REMINGTON ROAD

FLAT LAYOUTS CHANGES PROPOSAL REPORT

DELTA ARCHITECTS

REVISION: P1

TOWNHOUSE TH01 EAST

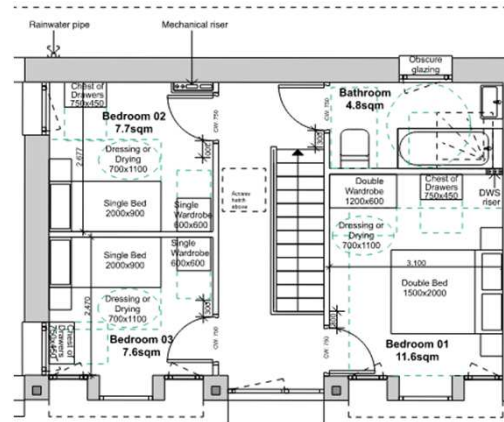
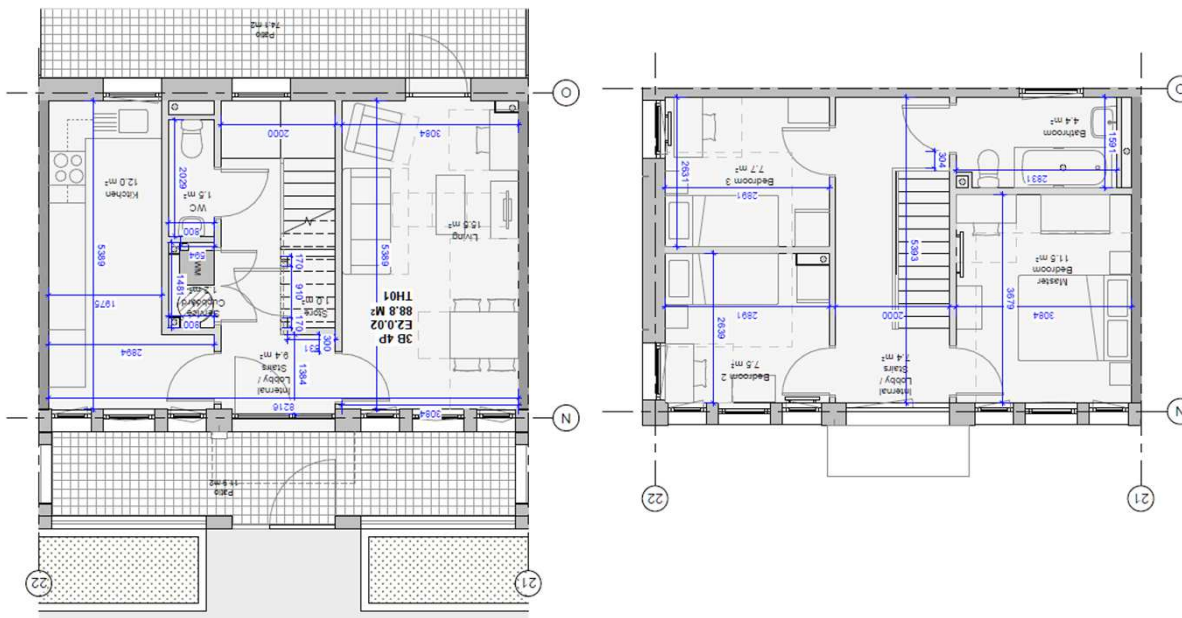
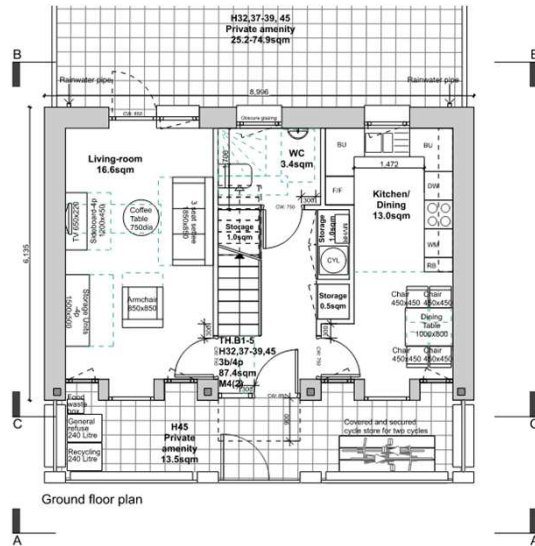
- Stairs landing Ground Floor – Not compliant with Part K. Stairs layout changed to comply.
- The pitch of the stairs was reduced and steps made wider to comply with Part K.
- Storage capacity reduced because of stairs layout changes.
- Ground Floor back door and a half changes to a single door. Elevational design rationalised.
- Drainage strategy resolved, SVP's and stacks added.

- Bay windows removed in Town houses due to constructability.
- Window on first floor resized to suit single door on ground floor.
- Drainage strategy resolved, SVP's and stacks added.

TOWNHOUSE TH01 WEST

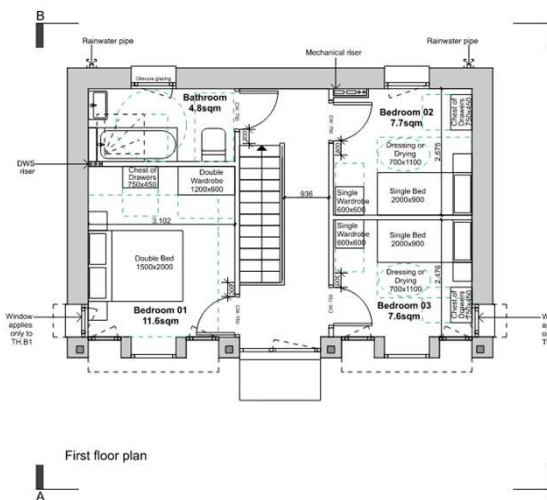
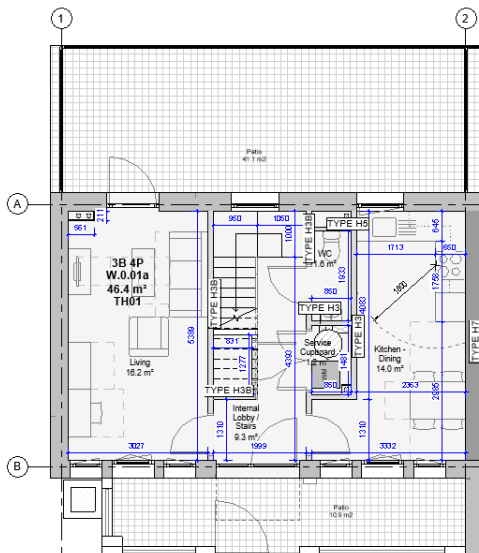
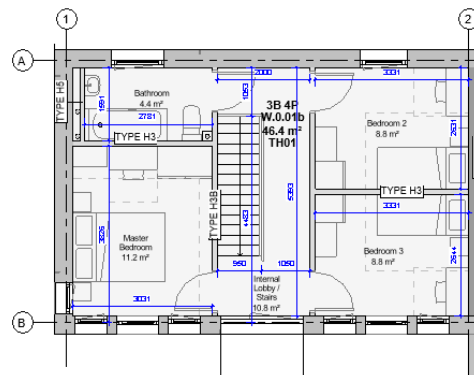
- Stairs landing Ground Floor – Not compliant with Part K. Stairs layout changed to comply.
- The pitch of the stairs was reduced and steps made wider to comply with Part K.
- Storage capacity reduced because of stairs layout changes.
- Ground Floor back door and a half changed to a single door. Elevational design rationalised.
- Drainage strategy resolved, SVP's and stacks added.

- Bay windows removed in Town houses due to constructability.
- Window on first floor resized to suit single door on ground.
- Drainage strategy resolved, SVP's and stacks added.
- Windows made to brick dims sizes.

TOWNHOUSE TH02 WEST

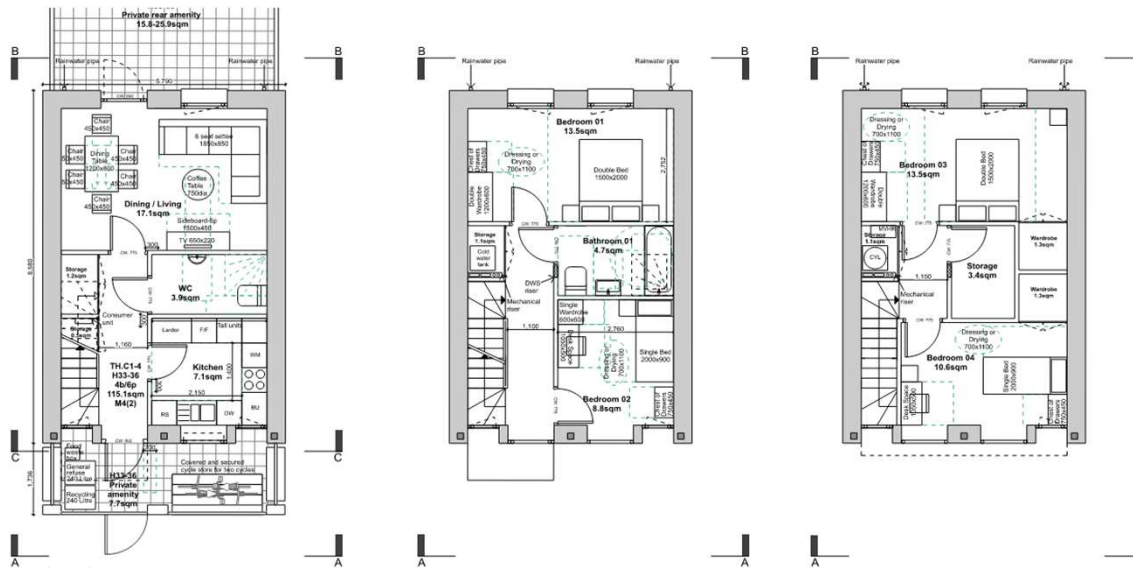
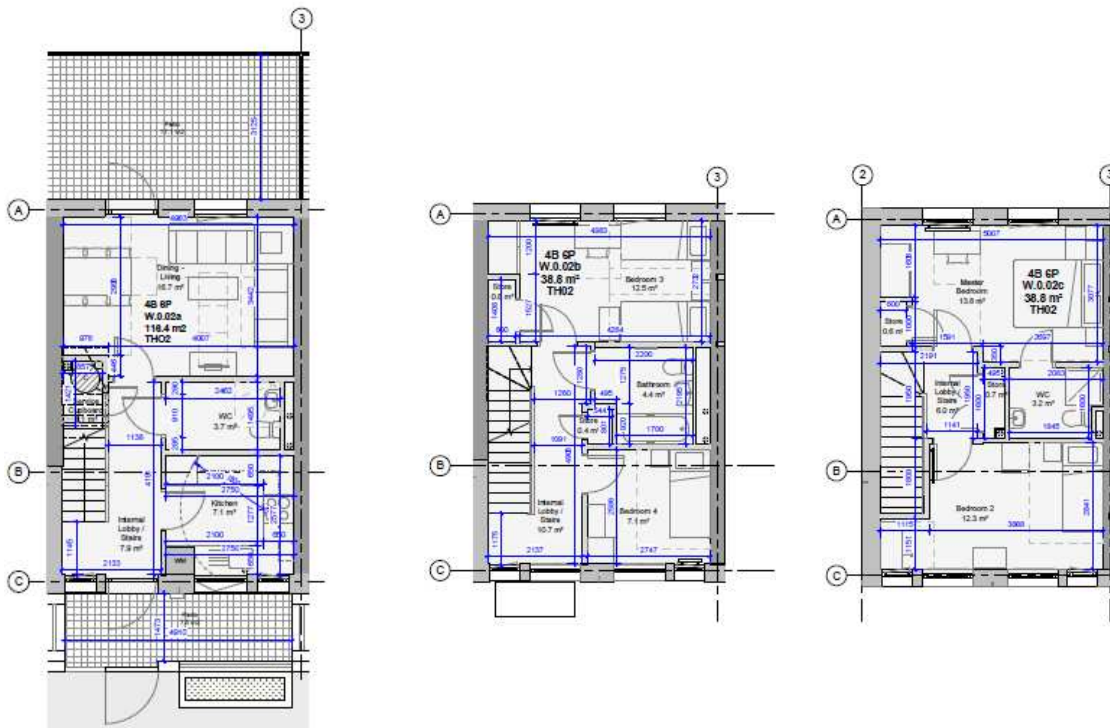
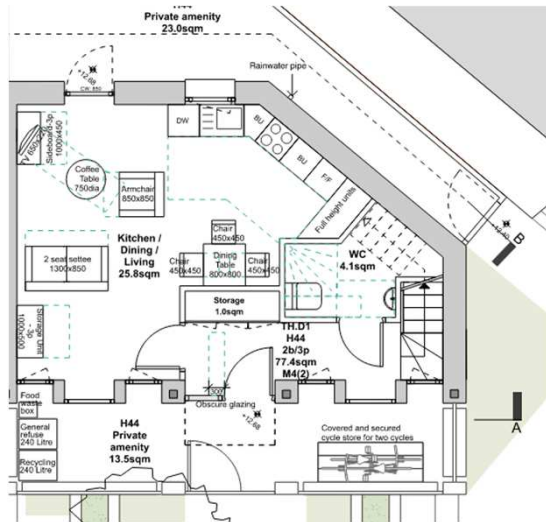
- Stairs amended to comply with Part K, storage moved in consequence.
- Drainage strategy resolved, SVP's and stacks added.

- Utility cupboard moved downstairs (Ground Floor) for M&E maintenance purpose.
- Drainage strategy resolved, SVP's and stacks added.

- WC added to 2nd floor to make the living space more disposable.
- Master Bedroom – Door flipped for 300mm nib required.

TOWNHOUSE TH03 EAST

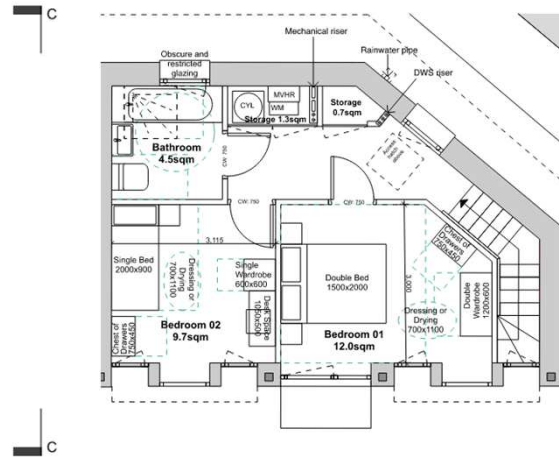
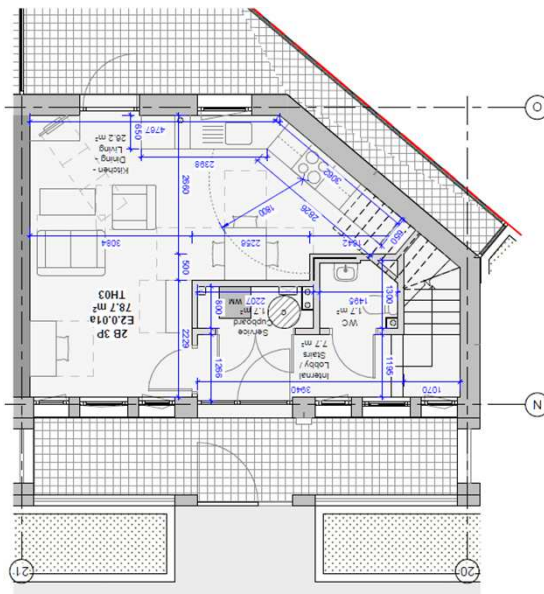
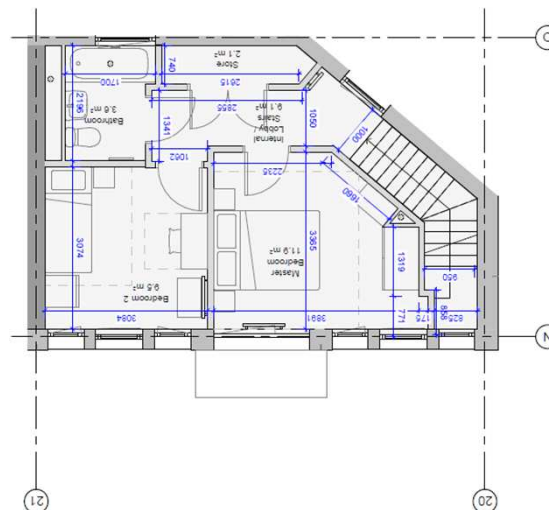
- Back garden gate removed in private amenity. House moved towards boundary line. Clear opening of gate didn't comply with part M. Patio width too narrow, 770mm.
- WC decreased due to stairs to upper floor. Kitchen space enlarged to increase cubic capacity.
- Increased Kitchen Storage
- Drainage strategy resolved, SVP's and stacks added.

- Utility cupboard moved downstairs (Ground Floor) for M&E maintenance purpose.
- Bay windows removed in Town houses due to constructability.
- Stairs increased in width and length to comply with Part K.
- Drainage strategy resolved, SVP's and stacks added.

TOWNHOUSE TH04 EAST

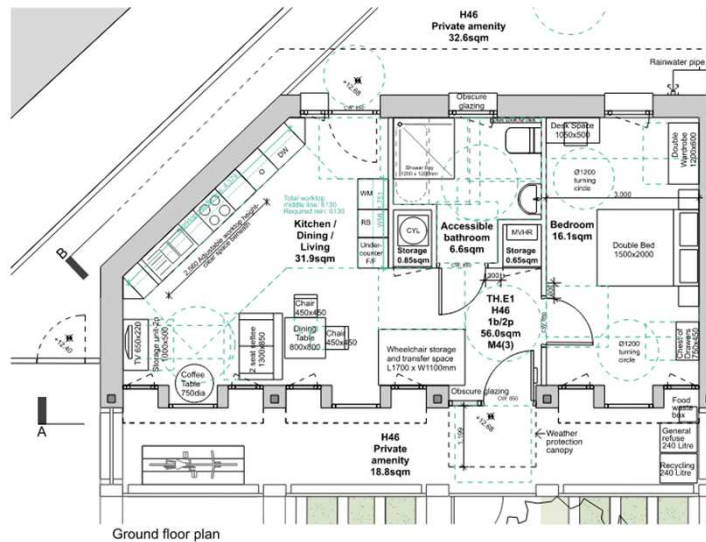
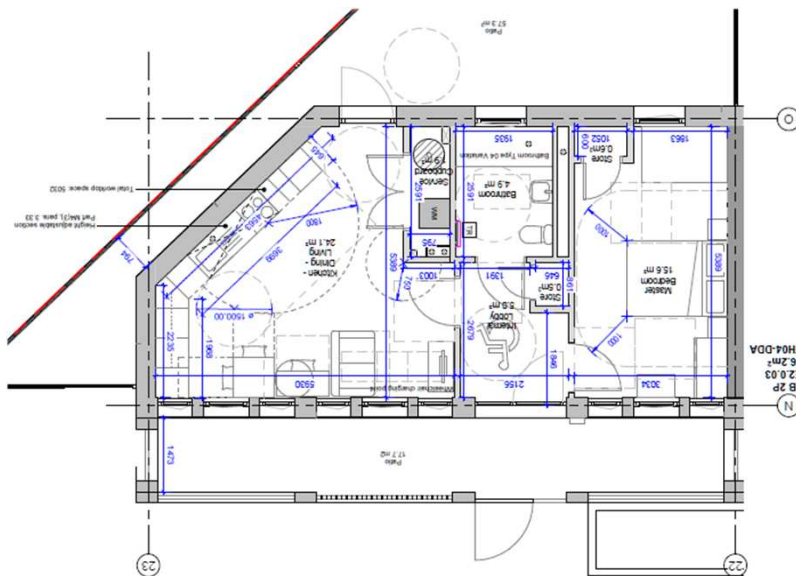
- Utility cupboard changed to be all in one cupboard.
- Lobby added at entrance for fire protection from wheelchair charging point.
- Living room layout and orientation changed due to the additional protected lobby to fire consultant recommendations.
- Drainage strategy resolved, SVP's and stacks added.
- Storage at planning stage not following part M4(3).
- Back garden gate removed in private amenity. House moved towards boundary line. Patio width too narrow, 794mm – not compliant with Part M.

FLAT FT02 – BLOCK C

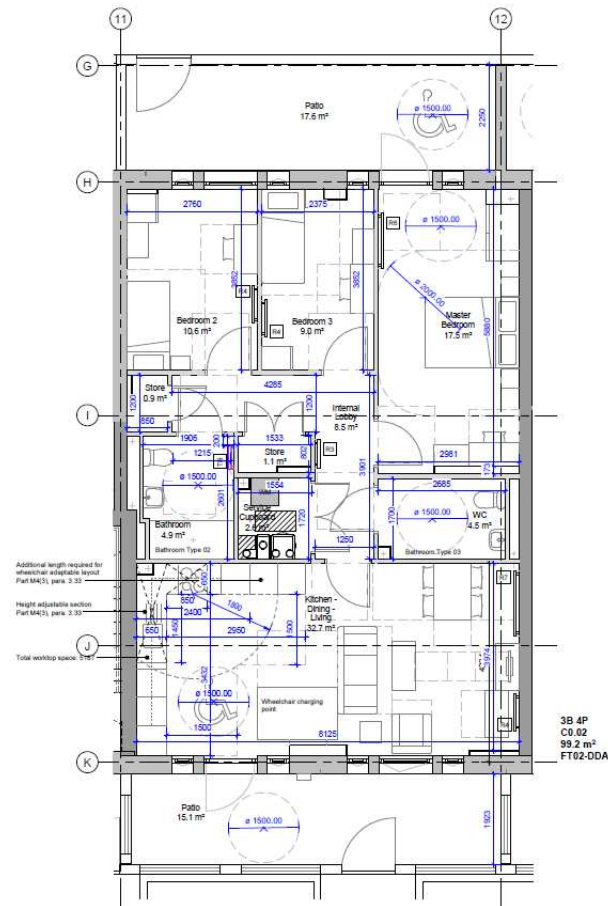
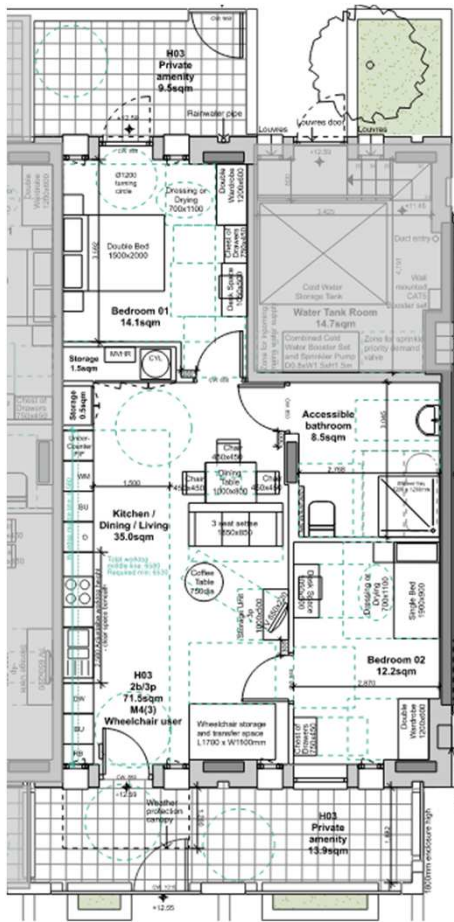
- Utility cupboard and storage re-arranged to improve minimum space required for approved M&E appliances.
- 7.5sqm lost in Living, Kitchen, Dining room .
- Drainage strategy resolved, SVP's and stacks added.
- Master bedroom increased by 1.8sqm.
- Store increased by 1.6sqm.
- Gate moved to allow 1500mm circle in the patios.

FLAT FT03 – BLOCK A

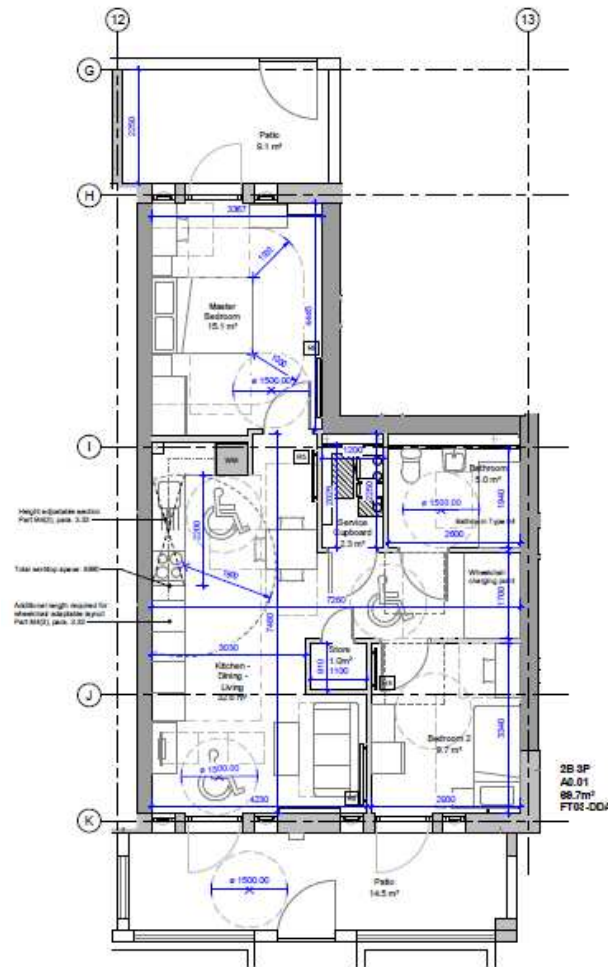
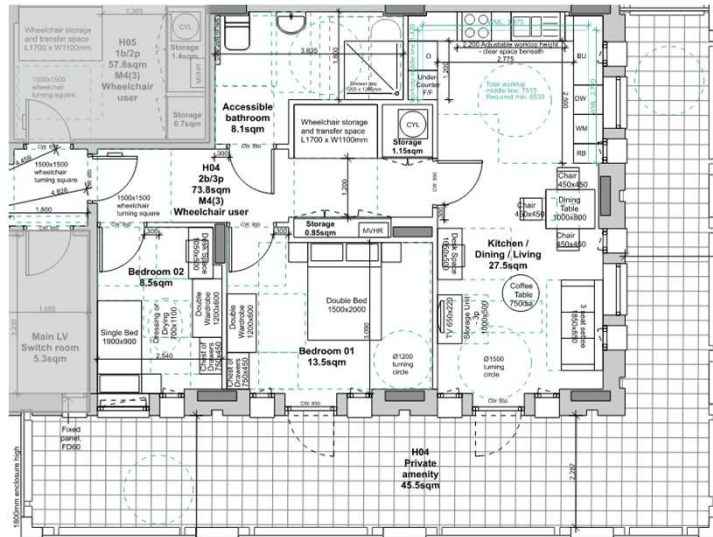
- Utility cupboard and storage re-arranged to improve minimum space required for M&E services.
- Wheelchair charging point moved to Fire Consultant comments – cannot interfere fire escape route.
- Drainage strategy resolved, SVP's and stacks added.
- Water tank room wall thickness increase therefore overall GIA reduced.
- Gate moved to allow 1500mm circle in the patio.

FLAT FT04 – BLOCK A

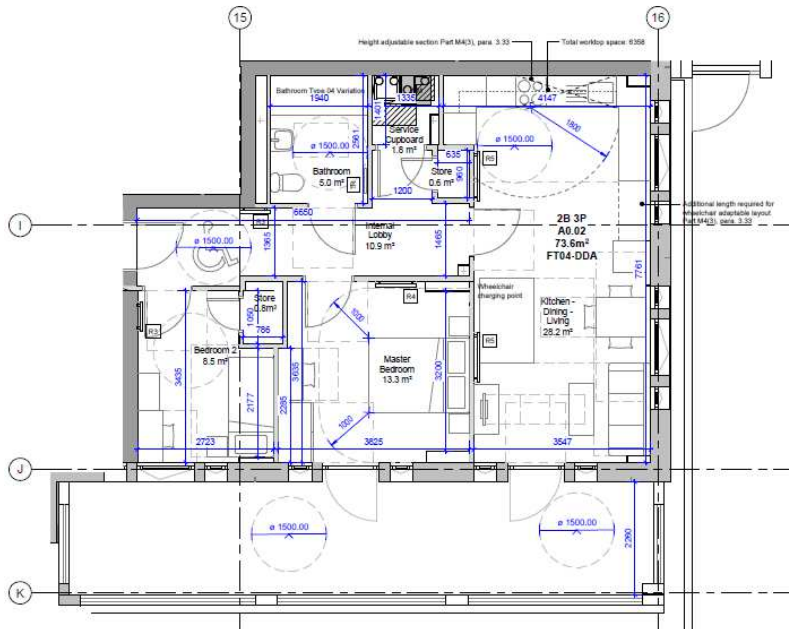
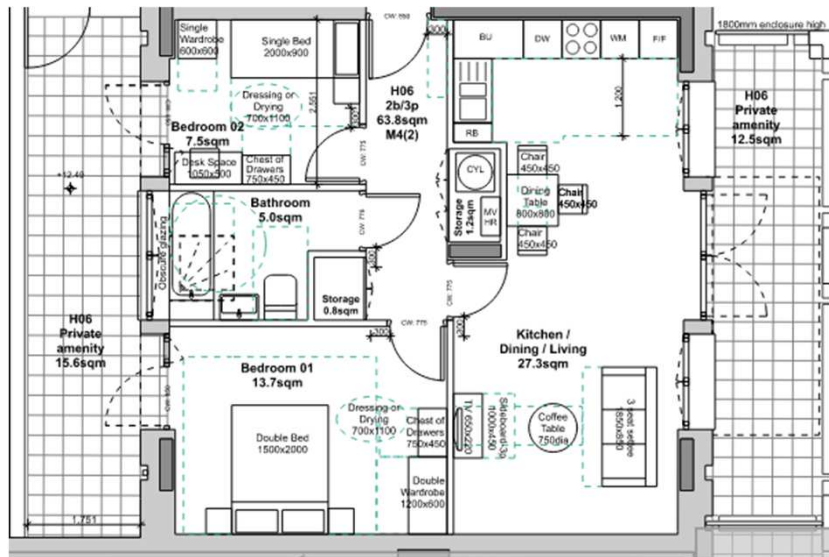
- Utility cupboard and storage re-arranged to improve minimum space required for M&E services.
- Drainage strategy resolved, SVP's and stacks added.
- Wheelchair charging point moved to living space.
- Cubic capacity and storage greater than planning approved.

FLAT FT06 – BLOCK B

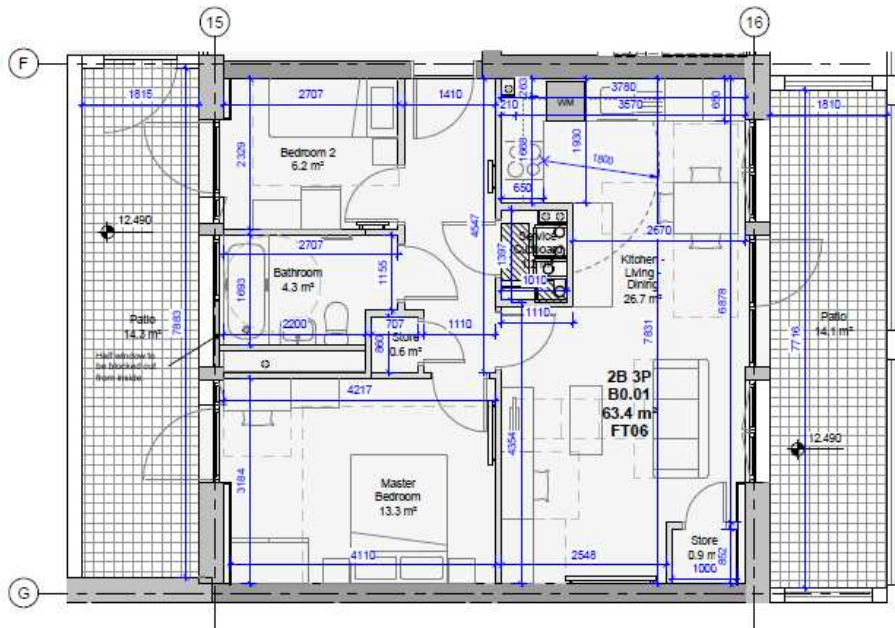
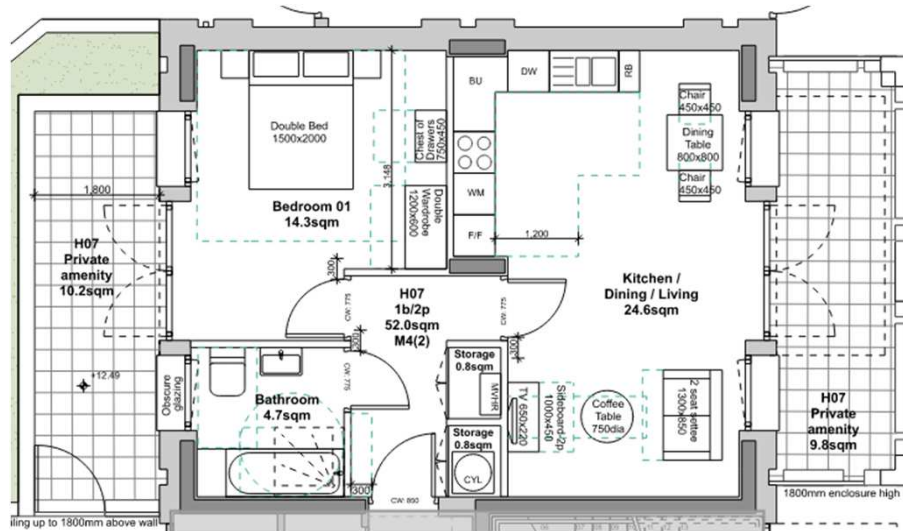
- Utility cupboard and storage re-arranged to improve minimum space required for M&E appliances.
- Drainage strategy resolved, SVP's and stacks added.

FLAT FT07 – BLOCK B

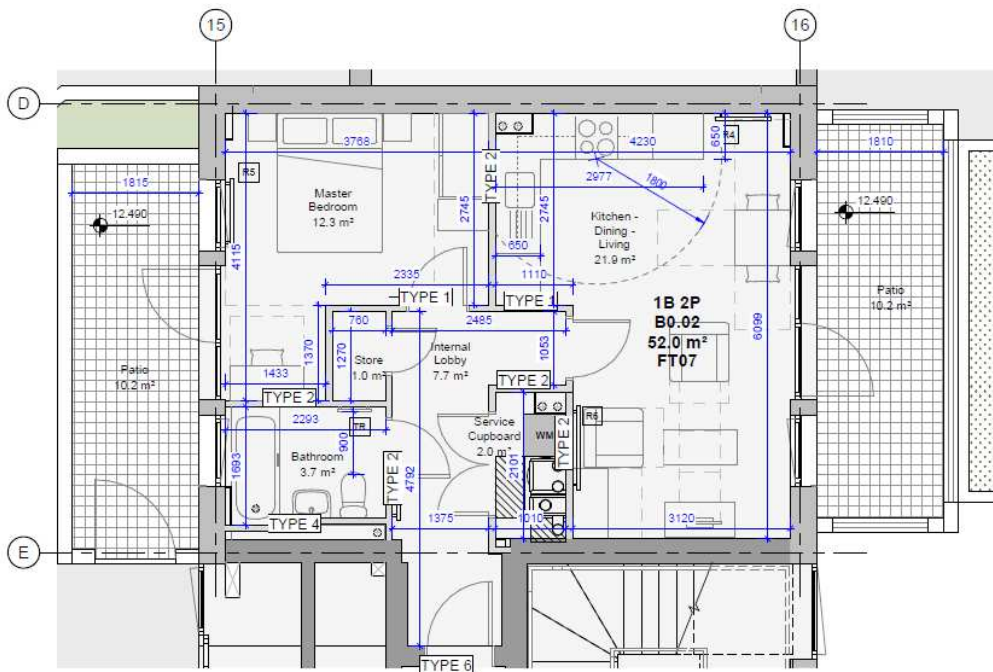
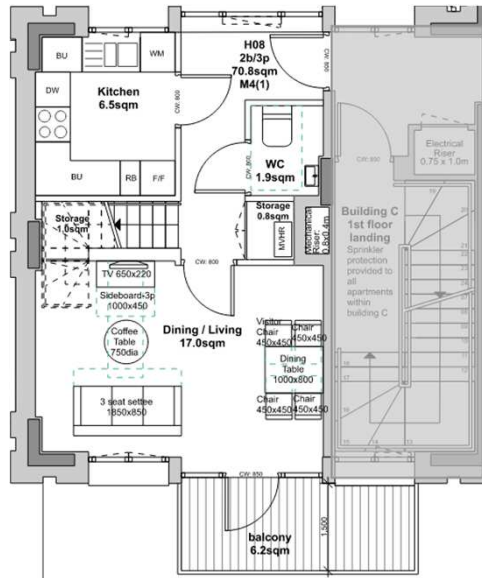
- Utility cupboard and storage re-arranged to improve minimum space required for M&E appliances.
- Bathroom layout standardised.
- Double doors to patio reduced to single doors to comply with Part M requirement of 850mm min clear opening.
- Storage capacity greater than planning approved.
- Drainage strategy resolved, SVP's and stacks added.
